SUBJECT: LASALLE COUNTY STATION, UNITS 1 AND 2 - ENVIRONMENTAL
ASSESSMENT AND FINDING OF NO SIGNIFICANT IMPACT RELATED TO
REQUEST FOR LICENSE AMENDMENTS TO TECHNICAL
SPECIFICATION 3.7.3, "ULTIMATE HEAT SINK" (EPID L-2020-LLA-0165)

ENCLOSURE
FEDERAL REGISTER NOTICE
ENVIRONMENTAL ASSESSMENT

LaSalle County Station, Units 1 and 2

ACTION: Environmental assessment and finding of no significant impact; issuance.

Figure 1. Current and Proposed Temperature of Cooling Water Supplied to the Plant from the CSCS Pond Versus Time of Day Requirements

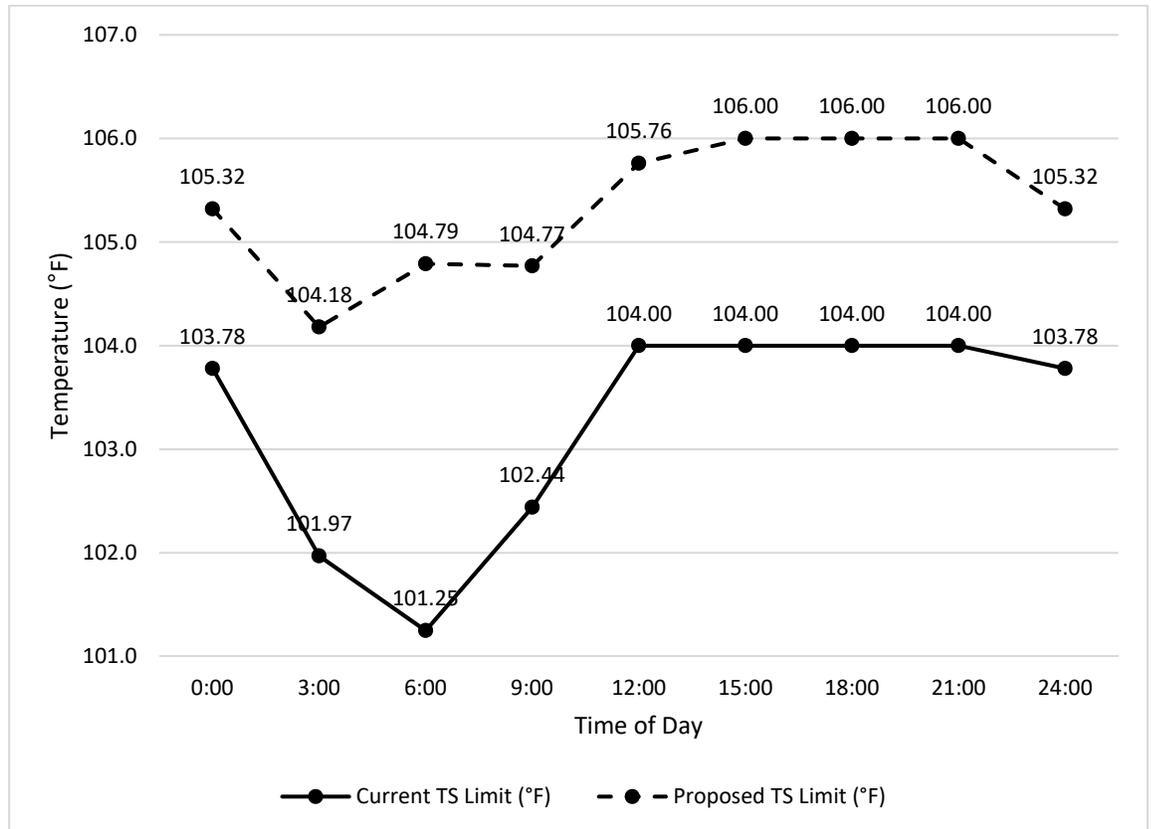
The proposed action would also modify the temperature curve associated with TS SR 3.7.3.1. This requirement currently states, "Verify cooling water temperature supplied to the plant from the CSCS pond is within the limits of Figure 3.7.3-1." Under the proposed action, Figure 3.7.3-1 would be modified to specify new diurnal temperature limits. The revised TS temperature limits would continue to vary with the diurnal cycle and would continue to limit the maximum temperature of the UHS supplied to plant safety systems to below 107 degrees Fahrenheit ($^{\circ}$ F) (41.7 degrees Celsius ($^{\circ}$ C)), the design limit of the plant. The revised limits would increase the allowable maximum UHS temperature of cooling water by 1.54 to 3.54 $^{\circ}$ F (0.85 to 1.97 $^{\circ}$ C) as compared to current limits and depending on time of day. Table 1 lists the current and proposed temperature limits, and Figure 1 depicts these limits graphically.

With regard to potential non-radiological impacts, raising the maximum allowable UHS diurnal temperature limits could cause the UHS portion of the cooling pond to experience increased water temperatures. Because the proposed action would not affect LaSalle's licensed thermal power level, the temperature rise across the condensers as cooling water travels through the cooling system would remain constant. Thus, if water in the UHS were to rise to the proposed allowable limits according to the proposed temperature curve, heated water returning to the cooling pond would also

experience a corresponding 1.54 to 3.54 °F (0.85 to 1.97 °C) increase compared to current limits and depending on time of day. That additional heat load would dissipate across some thermal gradient as discharged water mixes within the cooling pond.
